COLORADO
Division of Reclamation,
Mining and Safety
Department of Natural Resources

On May 22, 2023, The Division received the request for a Technical Revision (TR137) for the Cresson Project, File No. M-1980-244, proposing to expand the TR133 clay borrow source on the northern perimeter of the WHEX pit from 4.7 to 12.9 acres of disturbance. During the review of the material submitted, the Division determined that the following items need to be adequately addressed before TR137 can be considered for approval. Please respond to this Adequacy Review with the requested information and summarize each response to the numbered items below, in a cover letter titled "Adequacy Review Responses TR137, M-1980-244".

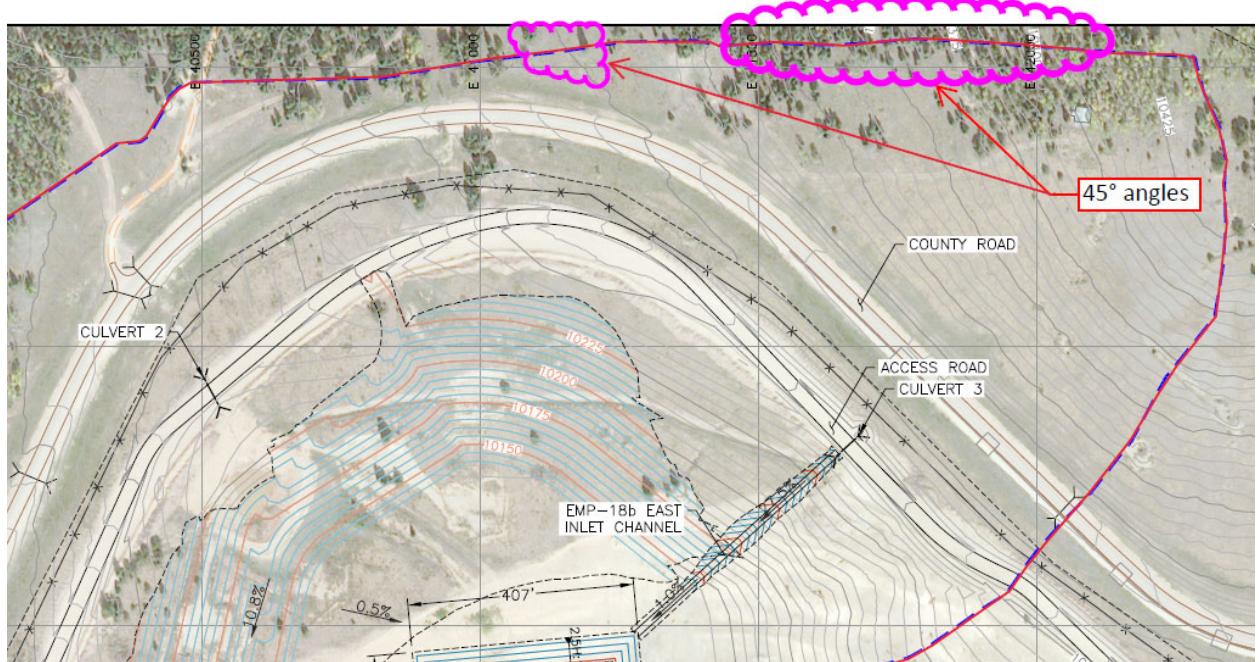
3. Watershed Area Boundary: The third bullet under section 1.0 Sediment Pond EMP-18B (NewFields Technical Memorandum WHEX POND Design, dated 10 May 2023) references the watershed area. Figure 2 presents the watershed boundary for the area contributing runoff to the proposed EMP-18b pond. There are multiple locations where the watershed boundary is at or near a 45° angle to the contour lines (see image capture below). Overland

flow runoff will flow perpendicular to contour lines. As the watershed map is cutoff north of the errant boundary, it is unclear what the magnitude of the error is. Please re-delineate the watershed boundary using accurate and accepted watershed delineation practice.
